Access Compliance Report

Public Rights-of-Way

Intersection ID: 23733	Main Street: ALLEGRO_CT	Cross Street: CEDAR_CROFT_DR	Location: E
ADA ID: 94559957A2F0	Ramp Type: PerpDiag	Initial Pass/Fail: Fail	Overall Compliance: No
Severity Score: 13.75			
Codes/Mitigation Info/Possible Solution		Field Measurements/Component Compliance

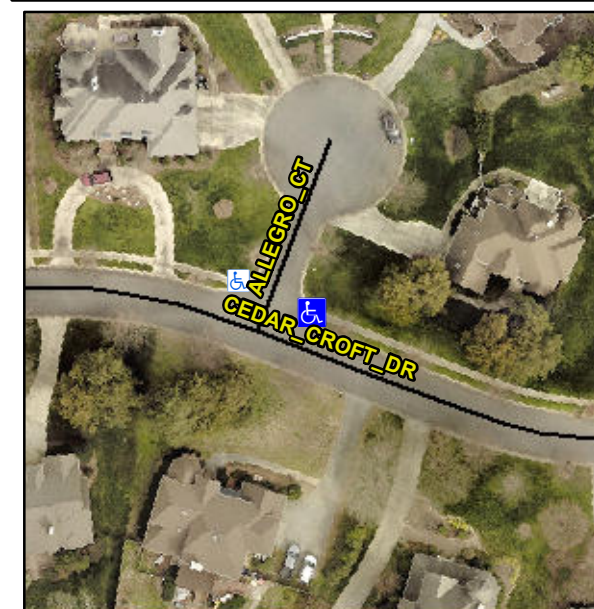
Not Found, R304.2.2, R304.5.3

Compliance	Description	Data	Compliance	Description	Data
N/A	Ramp Length (in)	35.2	No	Ramp Slope (%)	8.8
Yes	Ramp Width (in)	48.0	No	Ramp XSlope (%)	3.0
N/A	Flare Type LT	N/A	N/A	Flare Type RT	N/A
N/A	Flare Slope LT (%)	N/A	N/A	Flare Slope RT (%)	N/A
N/A	Flare Traversable LT?	N/A	N/A	Flare Traversable RT?	N/A
N/A	Landing Length (in)	N/A	N/A	DWS Provided?	N/A
N/A	Landing Width (in)	N/A	N/A	DWS Contrast?	N/A
N/A	Landing Slope (%)	N/A	N/A	DWS Length (in)	N/A
N/A	Landing X Slope (%)	N/A	N/A	DWS Full Width?	N/A
N/A	Landing Curb? (Y/N)	N/A	N/A	DWS Offset (in)	N/A
N/A	Shared Landing?	N/A			
N/A	Gutter Ponding?	N/A	N/A	Gutter Slope (%)	N/A
N/A	Gutter Lip Ht (in)	N/A	N/A	Gutter X Slope (%)	N/A
N/A	Painted X Walk1?	No	N/A	Painted X Walk2?	No
	X Walk 1 Direction	To NW		X Walk 2 Direction	To SW
N/A	X Walk 1 Width (in)	N/A	N/A	X Walk 2 Width (in)	N/A
	X Walk 1 Slope (%)	2.8		X Walk 2 Slope (%)	2.1
	X Walk 1 X Slope (%)	0.2		X Walk 2 X Slope (%)	2.9

Remove & Replace Curb Ramp With Two New Directional Ramps or Equivalent.
